SUBJECT: Grand Gulf Nuclear Station
Units 1 and 2
Docket Nos. 50-416 and 50-417
File 0260/0272/L-344.0
Human Factors Engineering Review
AECM-81/267

HUMAN FACTORS ENGINEERING
CONTROL ROOM DESIGN REVIEW FINAL REPORT
GRAND GULF NUCLEAR STATION
MISSISSIPPI POWER AND LIGHT COMPANY

FIGURE 2: STATUS LIGHTS, PUSHBUTTONS AND
REACTOR WATER LEVEL ANNUNCIATORS

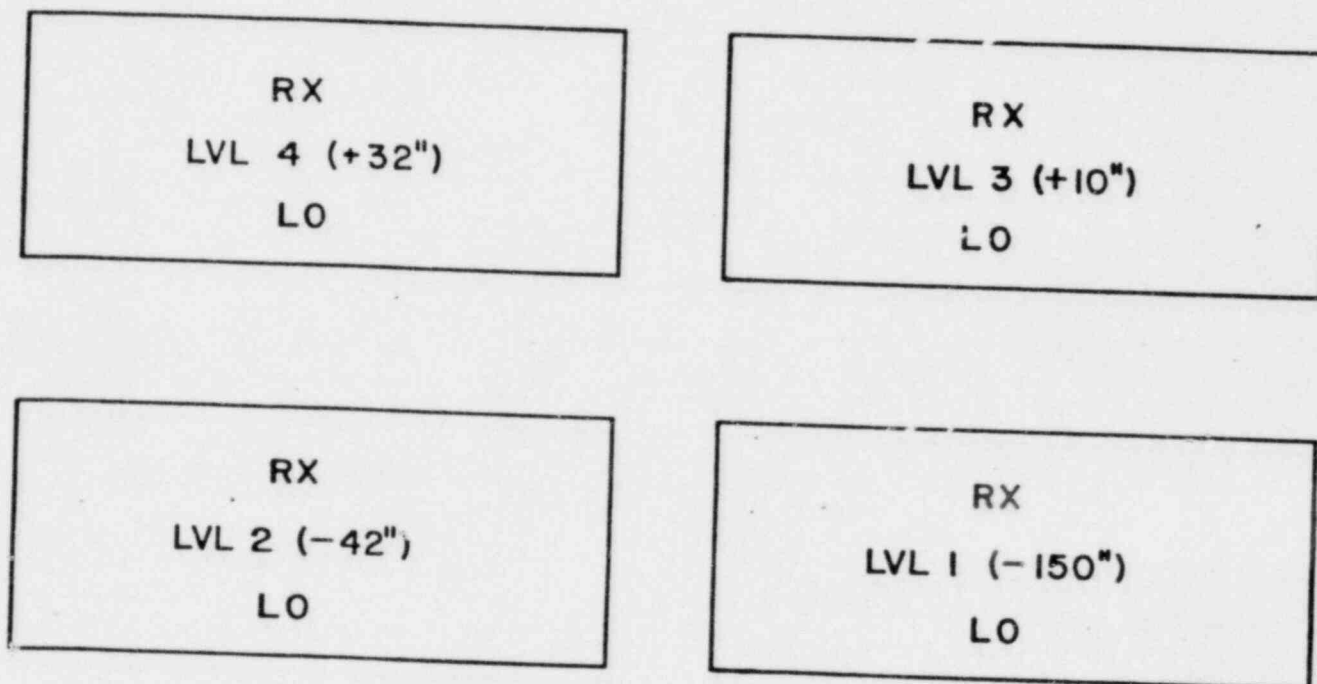
<u>ITEM</u>	<u>PRIORITY</u>	<u>FINDING</u>	
34	1	3.1	There is no annunciator to indicate NSSSS DIV 2 TRIP UNIT OOFFILE/PWRLOCS as there is for DIV 1 on Panel 601.
		<u>RESPONSE</u>	The present label is incorrect and will be revised to include all NSSSS divisional trip units. This discrepancy will be corrected prior to loading fuel.
35	1	3.2	The annunciator tile for RADWASTE BUILDING EXHAUST FILTER A DIFF PRESS HIGH is missing on Panel 854.
		<u>RESPONSE</u>	A new annunciator tile will be provided as part of the re-labeling effort for panel P854. This discrepancy will be corrected prior to loading fuel.
36	1	3.3	On Panel 601 and Panel 680, the REACTOR LEVEL LOW annunciators are illuminated for different low water levels within the reactor. However, the specific level associated with each annunciator alarm is not indicated by the annunciator legend.
		<u>RESPONSE</u>	The annunciator tiles dealing with REACTOR LEVEL LOW will be revised as indicated in Figure 2 to reflect specific levels. This discrepancy will be corrected prior to loading fuel.

Provision will be incorporated to readily distinguish the pushbuttons from the status lights as indicated by figure 2. This discrepancy will be corrected prior to loading fuel.
